ARTHUR KILL TERMINAL (AKT)

~~Draft~~ Final Scope of Work for an Environmental Impact Statement

CEQR #: 23DCP056R

APPENDIX 4: RESPONSES TO COMMENTS ON THE DRAFT SCOPE OF WORK

Figure 3
Illustrative Site Plan

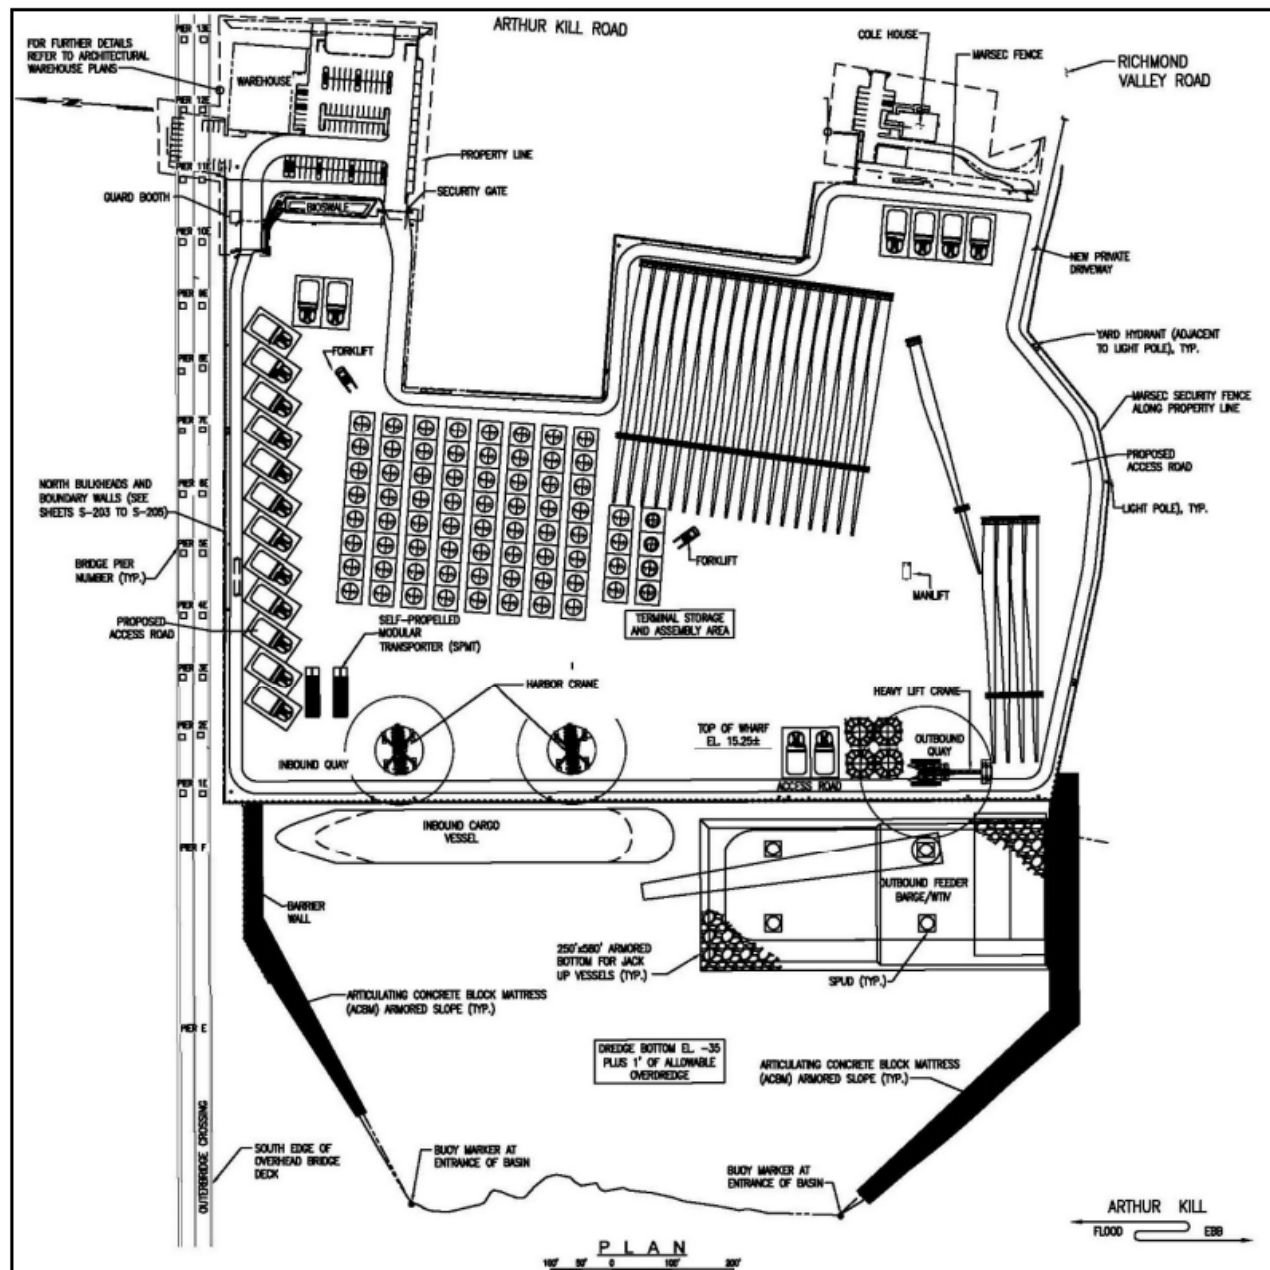
Comment 2: There are discrepancies throughout the Draft Scope regarding the dredge depth for the AKT Project. For example, page 9 states that, “construction activities would include installation of a 1,365 linear-foot heavy load bearing quay, and dredging of a basin to -33 feet NAVD88 from the wharf along the Bulkhead Line for the Project Site to the NY/NJ State Boundary in the Federal Navigational Channel.” In contrast, page 11 states that, “the Proposed Project includes the dredging of an approximately 18-acre navigable Dredge Basin to a depth of -36 ft NAVD88 (including 1 ft over-dredge allowance) from the quay located along the Bulkhead Line to the NY/NJ State Boundary. Figure 6 has a dredge bottom of -35. These inconsistencies should be corrected in the DEIS. (1)

Response 2: *All references in the FSOW have been updated to indicate that the Dredge Basin would be dredged to a depth of -35 dredge bottom plus 1' of allowable overdredge, including Figure 3, "Illustrative Site Plan". Figure 6 does not show dredge depth information. This information will also be reflected in the Draft Environmental Impact Statement (DEIS).*

*This Figure has been updated for the FSOW

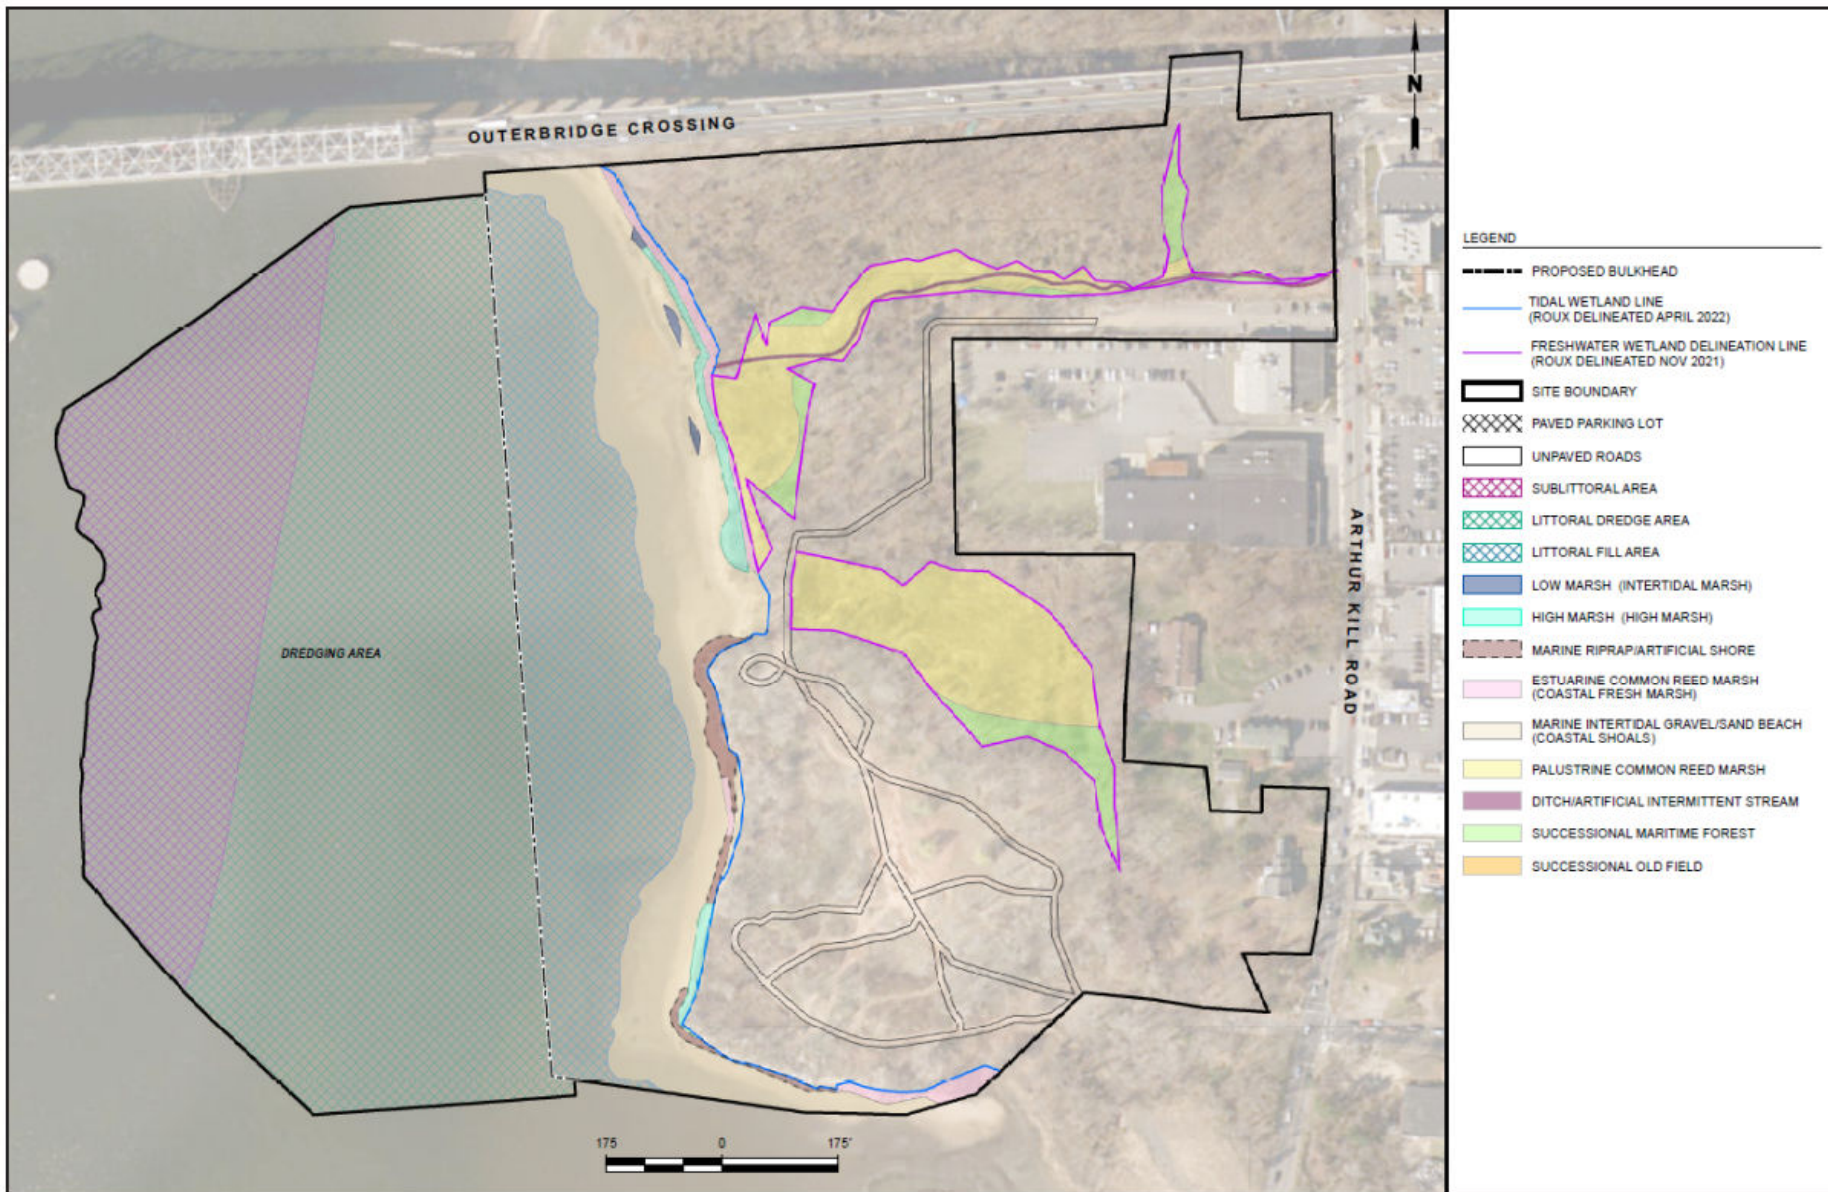
Comment 5.4: The tidal wetland categories in Figure 6 of the Draft Scope do not correspond with NYSDEC's Tidal Wetland categories. To determine the impacts to tidal wetlands from the AKT Project, existing conditions must be quantified according to NYSDEC tidal wetlands categories (see ECL Article 25, 6 NYCRR Part 661 Tidal Wetlands Land Use Regulations). When describing the expected changes to the tidal wetland zones as a result of the AKT Project, the DEIS should separate the extent of littoral habitat lost due to filling and dredging to deeper depths. (1)

Response 5.4: *Figure 6 has been updated in the FSOW to be consistent with NYSDEC's Tidal Wetland categories. The littoral habitat lost due to filling and dredging will be reflected separately in the DEIS.*
